Technical Review Memorandum

To: Washington Department of Ecology
From: Mark Yinger, LHG, Hydrogeologist
Date: February 3, 2012
Re: Aspect Consulting Report - Husum/BZ Corner Subarea Rezone

Proposed County Zoning

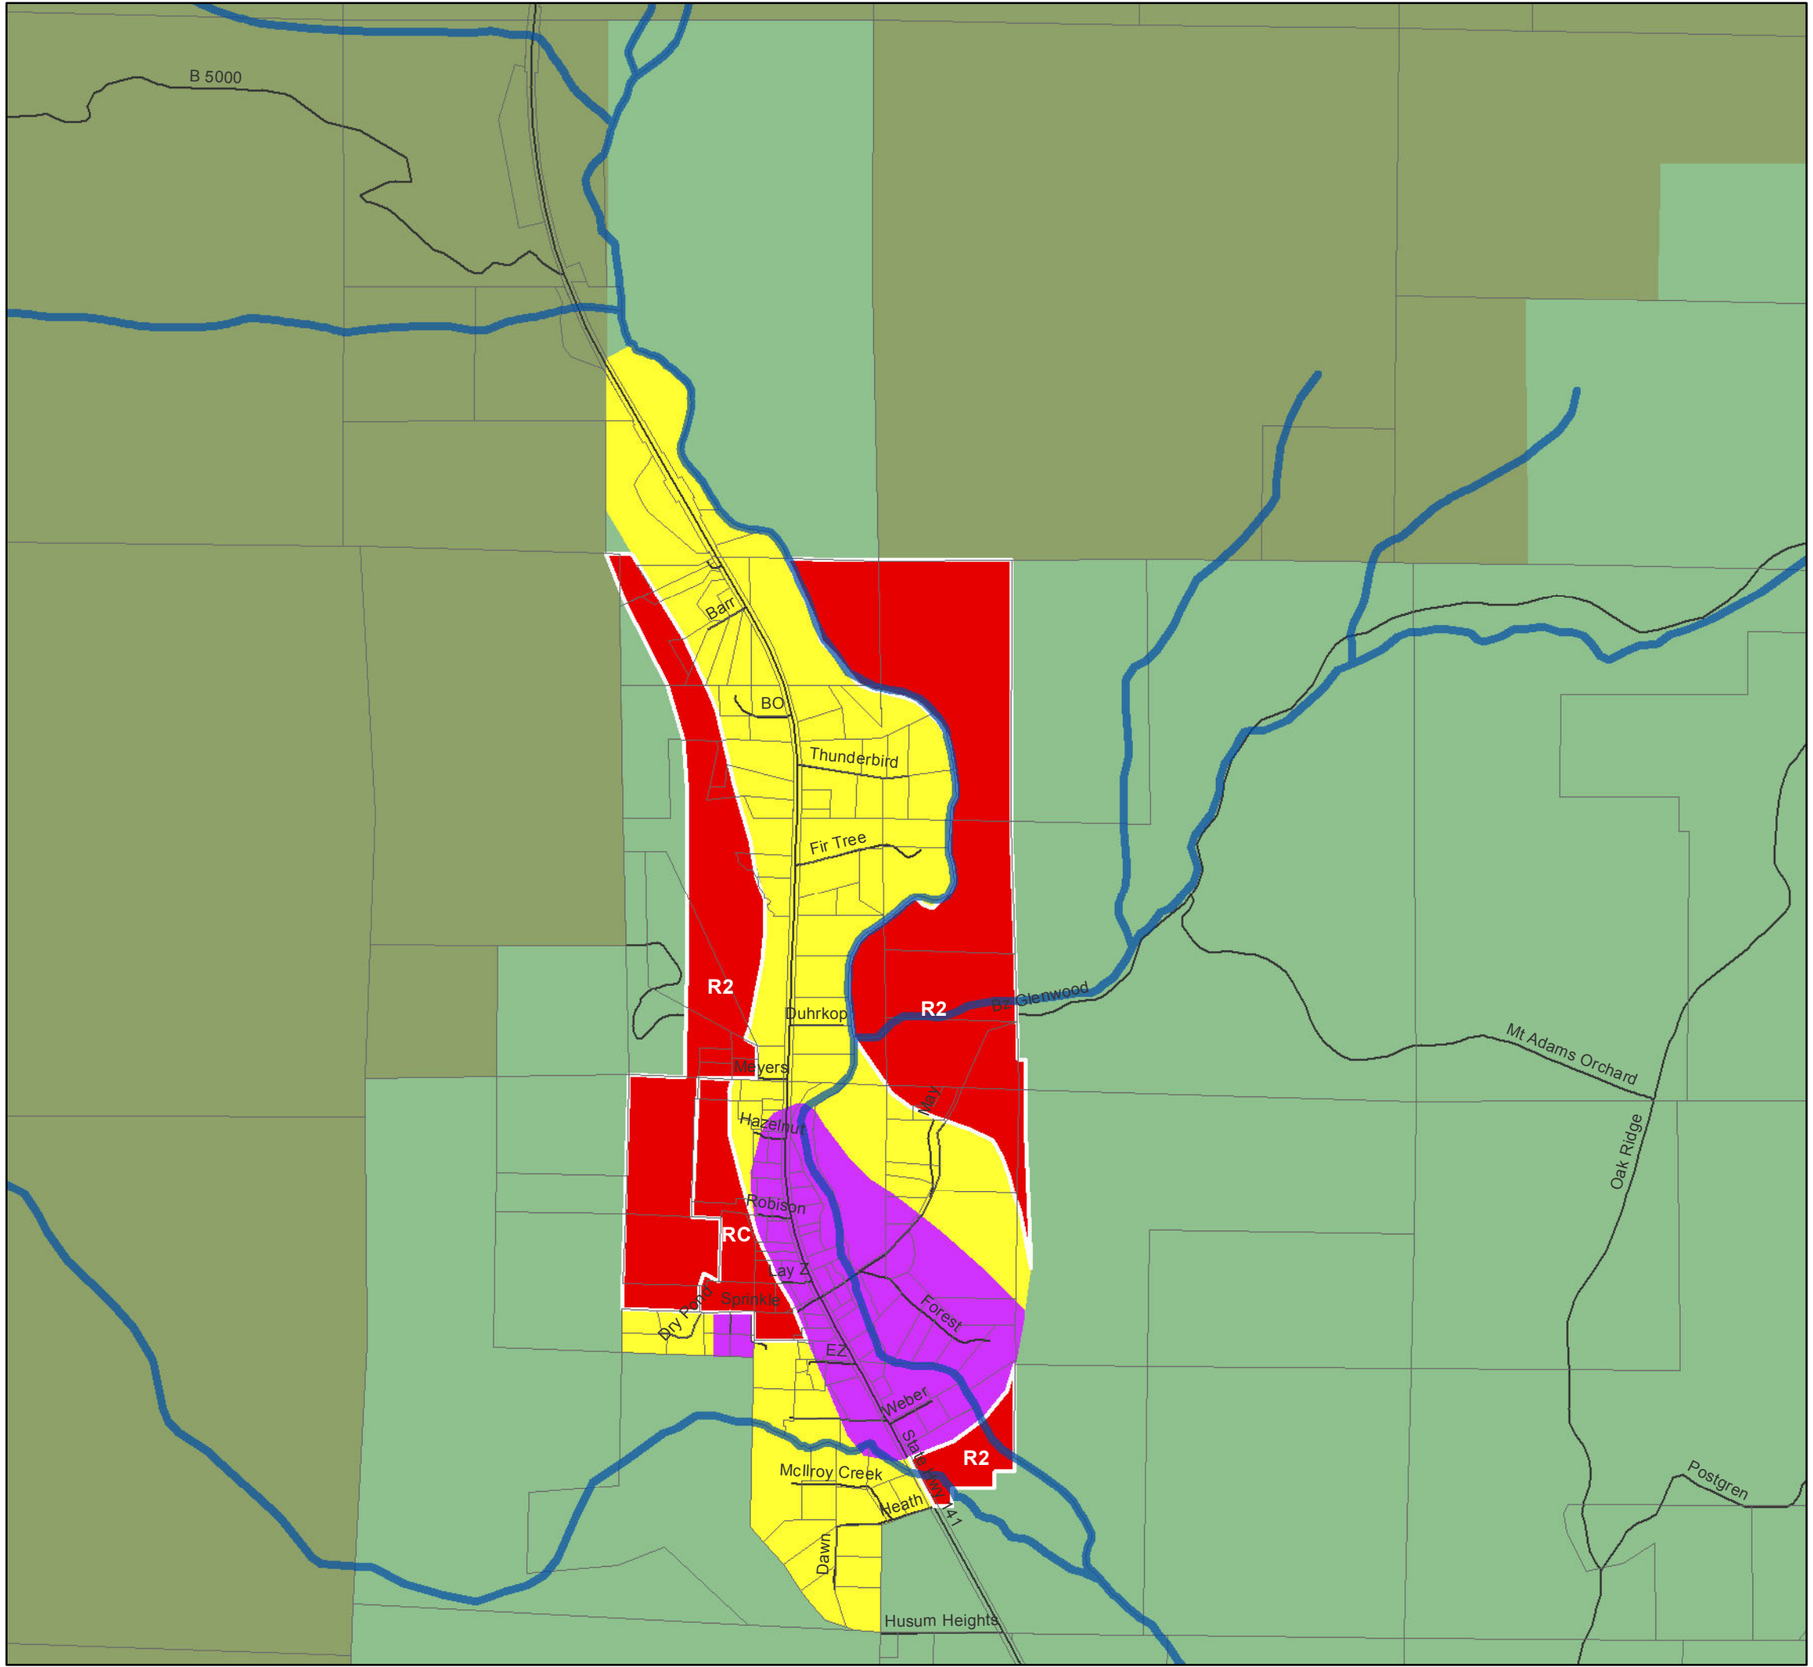
Because the Aspect report ignores the hydraulic connection between the shallow Quaternary aquifer and the CRB aquifer, it fails to disclose and identify the critical aquifer recharge area surrounding the Fordyce Well #1. The Aspect report does not even state that Fordyce Well #1 relies on a Critical Aquifer Recharge Area, let alone attempt to identify the location of the recharge area for this public water system (Aspect report p. 24). This is a critical omission. The identification of a critical aquifer recharge area for the Fordyce well is needed to protect this important public water supply from interference and contamination.

Proposed County Zoning

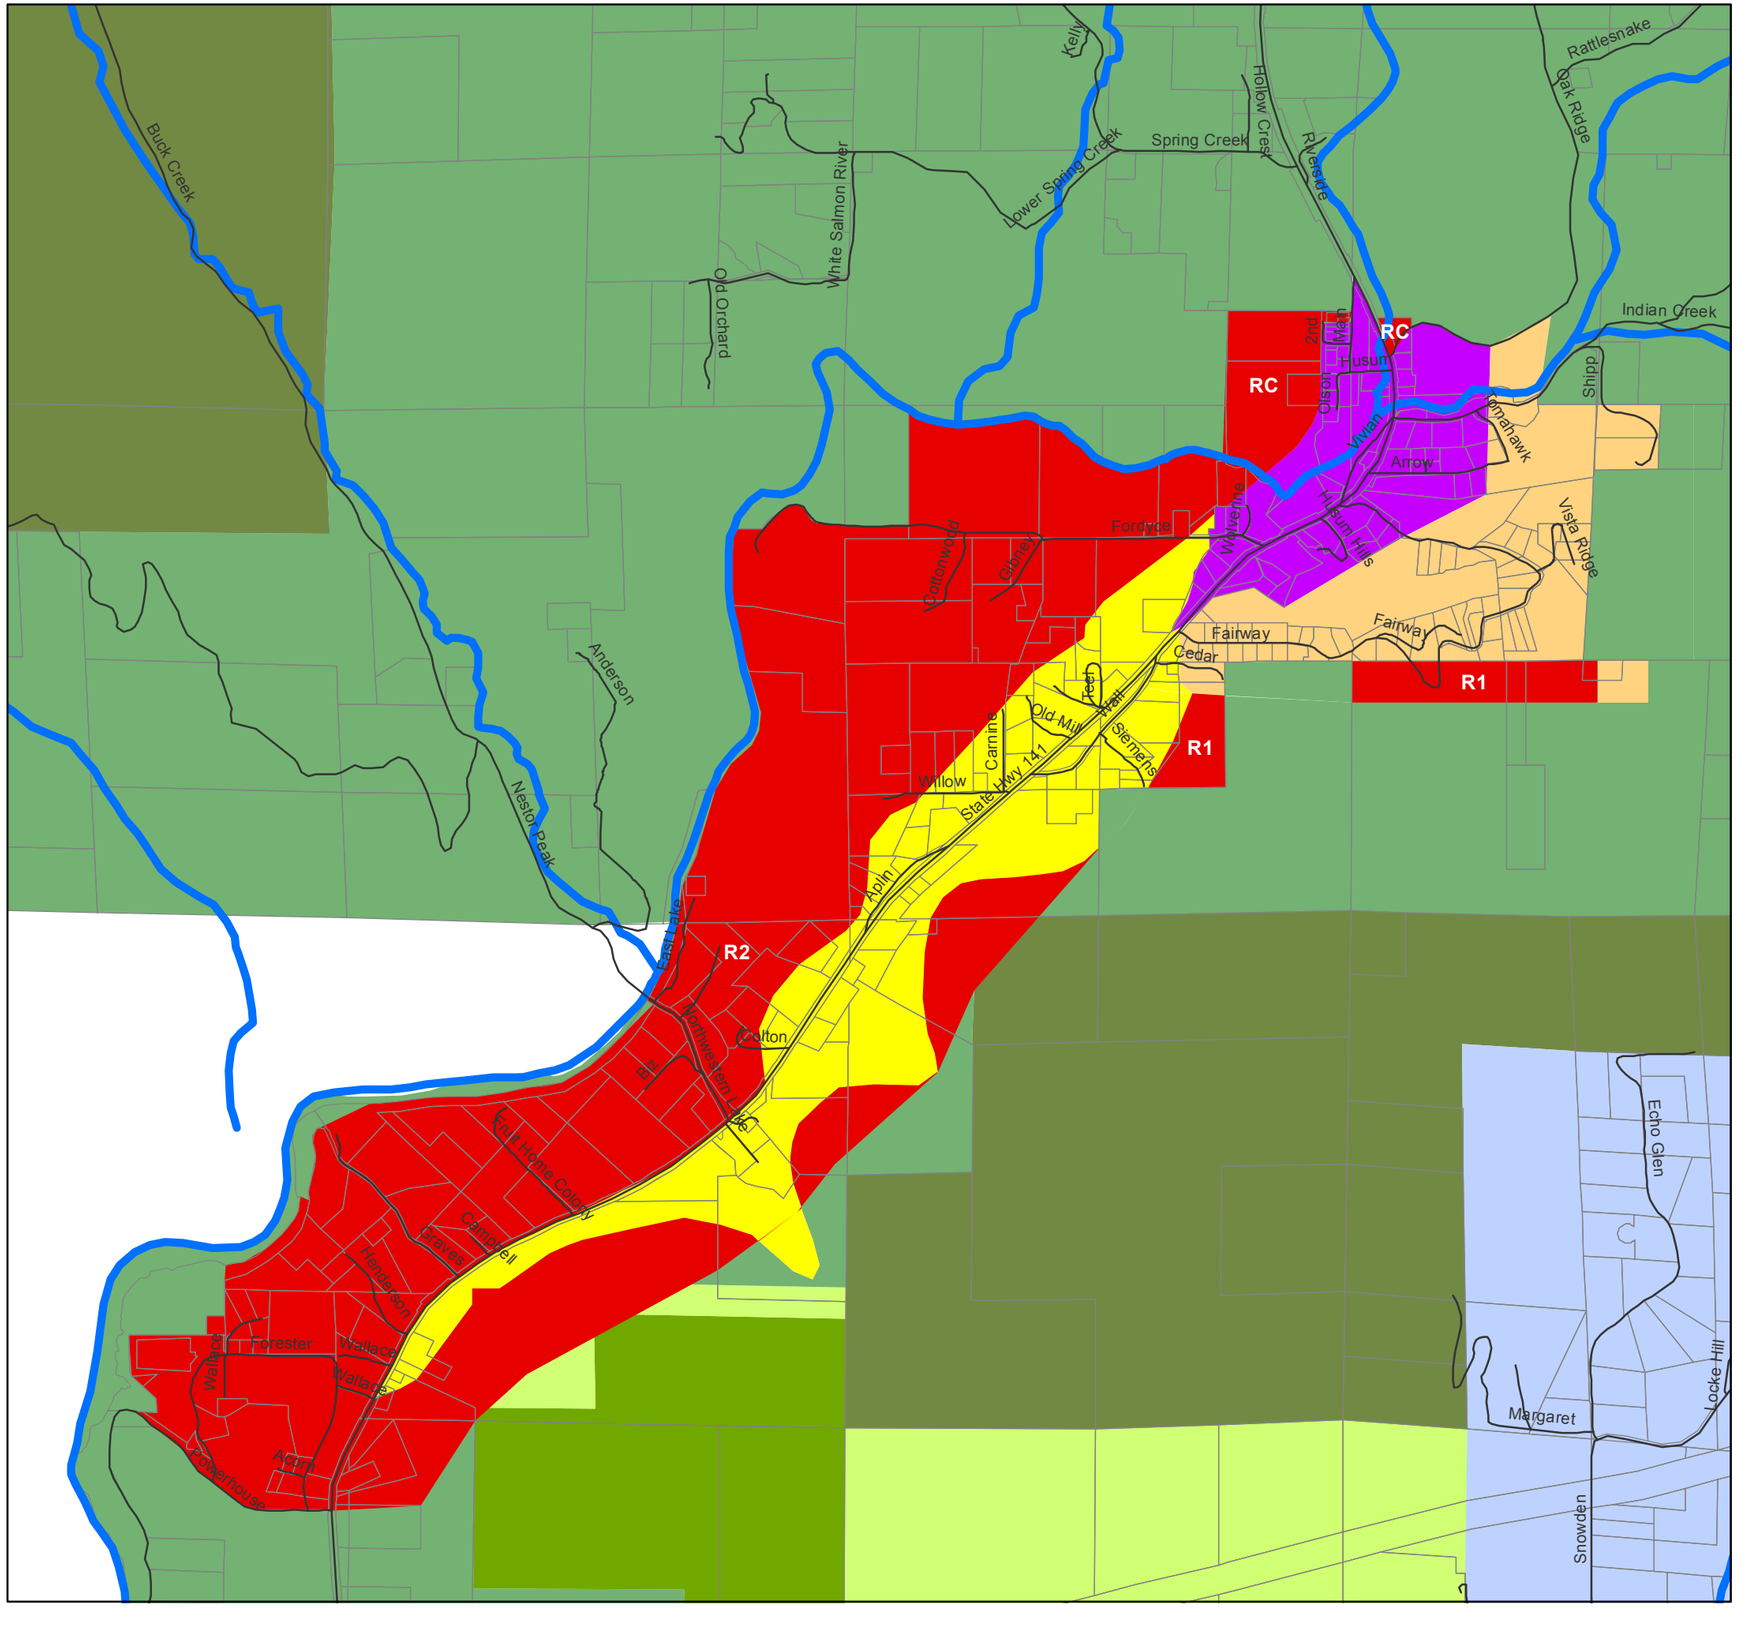
The report presents an evaluation of the impact on groundwater quality due to nitrate concentrations in discharges from sewage drainfields. This presentation is fundamentally flawed, and therefore, should be disregarded. Aspect used a grossly oversized drainfield when applying Ecology's simple mass balance mixing model to estimate nitrate concentration in groundwater downgradient of a hypothetical community septic drainfield in the Husum RC area.

The Aspect report authors assume the drainfield is the same size as the lot, even in RC zoning where a community sewage treatment system is required for build out at the allowed density. This modification from a default 1,000 square foot drainfield per residence to up to an 87,000 square foot drainfield per residence is a gross misuse of the model and without any foundation in science.
